BUILDING PLAN
FOR
TOTAL BODY THERAPY & WELLNESS
260 PINE STATE STREET
LILLINGTON, NORTH CAROLINA

TOWN OF LILLINGTON

RE: TOTAL BODY WELLNESS AND THERAPY

Please see the below response to comments for the above-referenced project.

ELECTRICAL
1/8" = 1'-0"

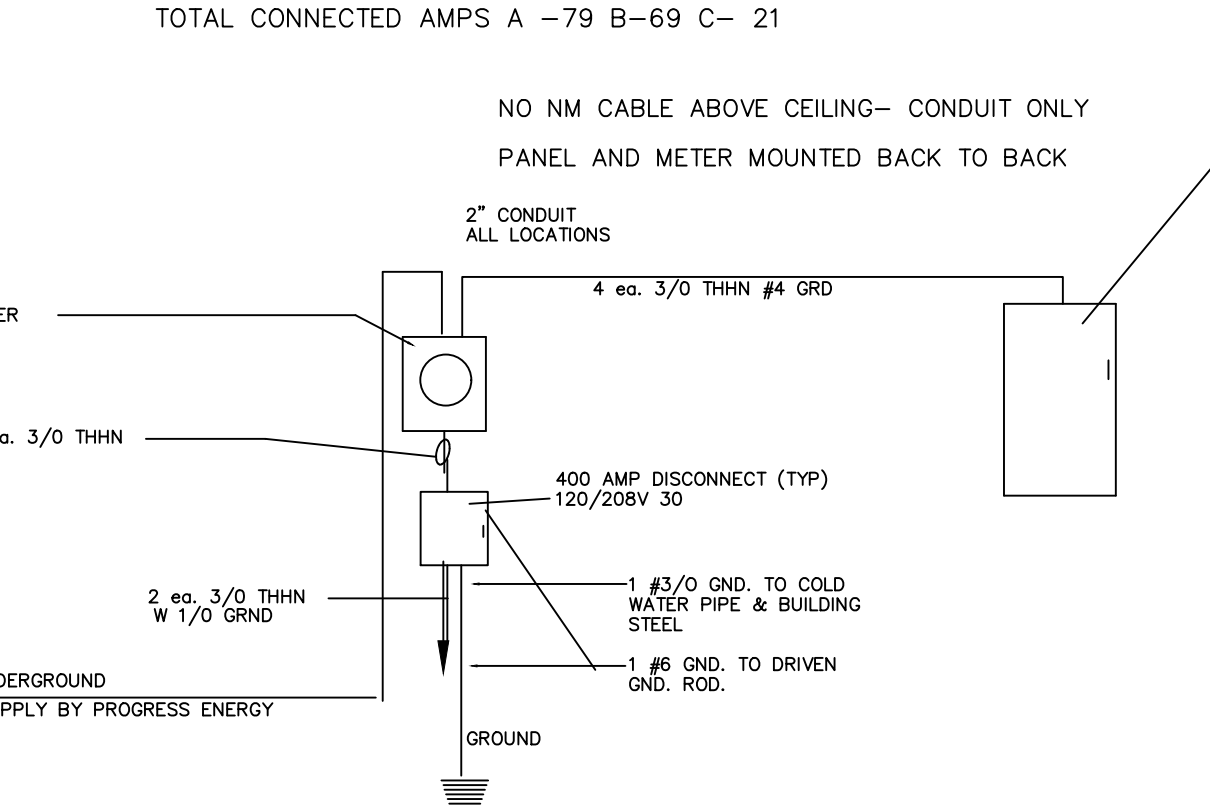
- No layout for electrical receptacles. **Electrical Receptacles shown on Electrical 1 Plan .**
- Occupant sensors? **Occupancy sensors are installed throughout ad noted on the Electrical 1 Plan.**
